NP-12-0030  
July 12, 2012

Subject: Exelon Nuclear Texas Holdings, LLC  
Victoria County Station  
Early Site Permit Application  
Environmental Report – Response to ER RAI Letter No.16  
Docket No. 52-042

References: (1) USNRC letter to Ms. Marilyn C. Kray, Environmental Request for Additional Information Letter No.16 Related to Socioeconomics and Environmental Justice for Victoria County Station Early Site Permit Application, dated May 31, 2012

Figure 6461-1 Victoria County Station Site School Districts

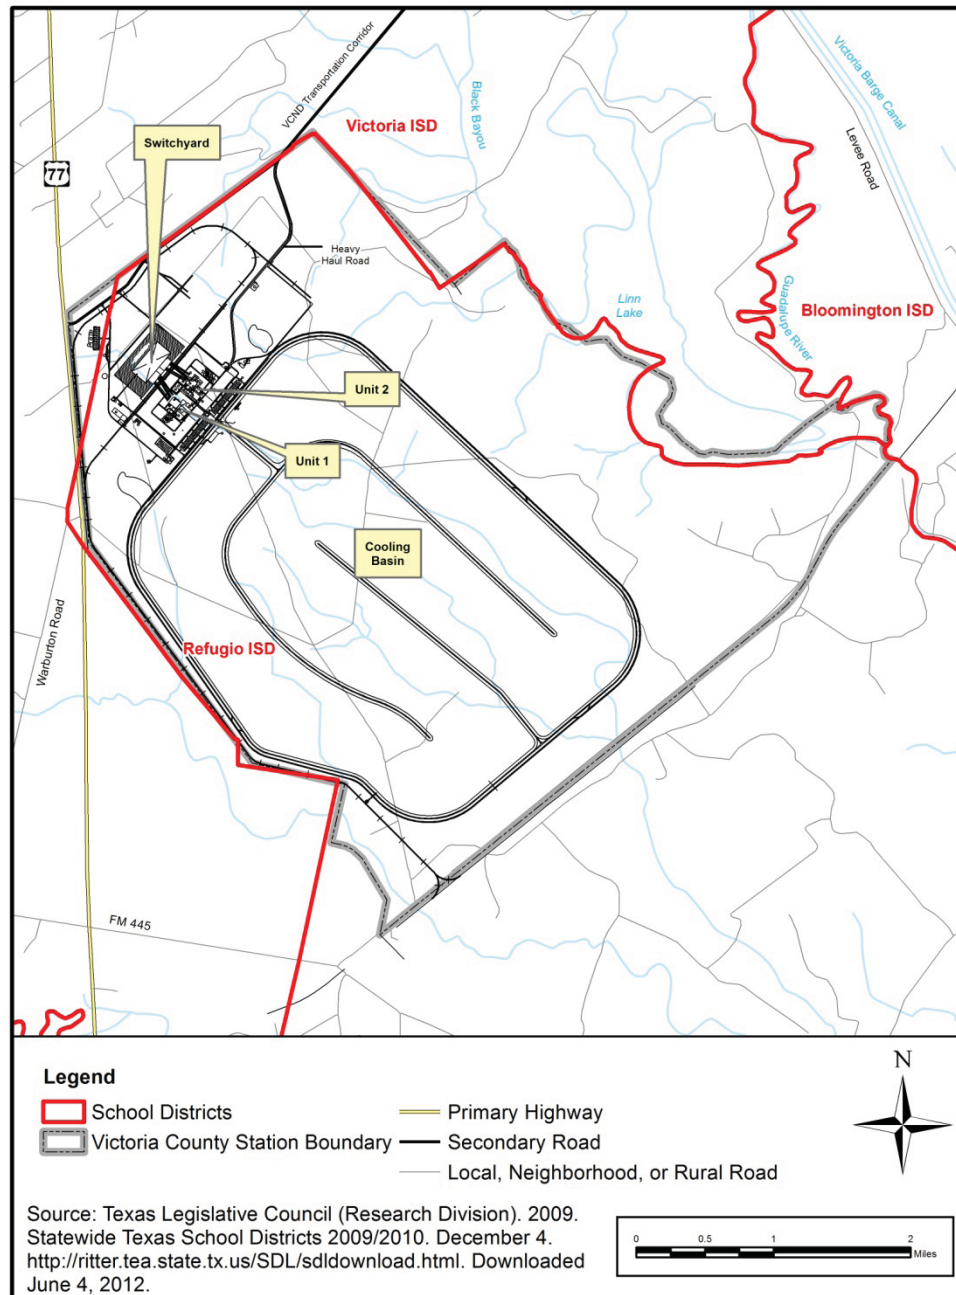
SE 2.5.2.8-2 ESRP Section 2.5.2 directs the staff to review the applicant's schools and higher education capabilities data presented in the ER. In correspondence from Exelon Generation on May 5, 2011 (NP-11-0015; D087 LIRO), updated information was provided indicating that the VCS site consists of 11 total parcels, with 9 of those parcels in the Refugio ISD and 2 parcels in the Victoria ISD. Although this topic is discussed in the ESP ER Section 2.5.2.3.5, updated pertinent information and discussions about funding issues for the Refugio ISD and Victoria ISD should also be provided in ESP ER Sections 2.5.2.8.1.5 and 2.5.2.8.1.6. The ESP ER Section 4.4.2.2.2 (page 4.4-26) indicated that the power block would be located in the Victoria ISD, but discussions with local leaders during the Site Audit indicated that the power block would be located in the Refugio ISD. Confirm the proposed location of the power block and describe Victoria ISD's "property-poor" (Chapter 42) property tax revenue status and Refugio ISD's "property-wealthy" (Chapter 41) status in Section 2.5.2.8, as a baseline for understanding later impact analyses. Provide additional school/education information for ER Section 2.5.2.8.

The new Appendix B contains updated information in Table B2.5.2-49, "Revenue Sources for ISDs in the ROI – Percent." Most of the VCS, including the powerblock, is located in the Refugio ISD. The wording in Section 4.4.2.2.2 is incorrect; however, the data presented in Table 2.5.2-19, "Proposed VCS Site Parcels and Assessed Value" (and its update Table B2.5.2-19) and in Table 2.5.2-23, "Property Taxes Paid on Proposed VCS Site ISDs" (and its update in Table B2.5.2-23) indicate that most of the property taxes are paid to the Refugio ISD.

Figure 6461-1 shows the boundary of the nearby ISDs superimposed on the VCS site layout. Although the GIS data were prepared at different scales, and thus, do not match perfectly at the scale used in this figure, it is clear that VCS is predominantly in the Refugio ISD.
